Access Compliance Report

Public Rights-of-Way

(Curb Ramps)

Intersection ID: 3273	Main Street: BILLINGHAM_DR	Cross Street: PROSPERITY_CHURCH_RD	Location: NE
ADA ID: F1D0296C4806	Ramp Type: ParaDiag	Initial Pass/Fail: Fail	Overall Compliance: No
Severity Score: 13.75			
Codes/Mitigation Info/Possible Solution		Field Measurements/Component Compliance

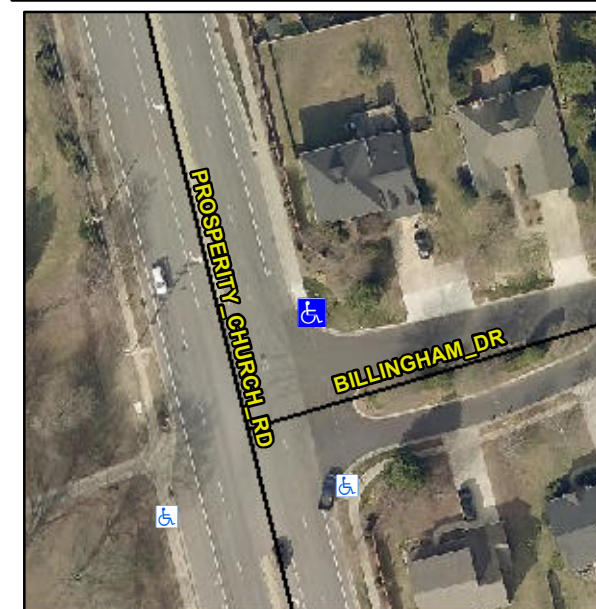
Surveyor Notes:

RT RP < 5%

PROW/ADA:

R304.3.2, R304.5.3

Possible Solutions:

Remove & Replace Curb Ramp With Two New Directional Ramps or Equivalent.
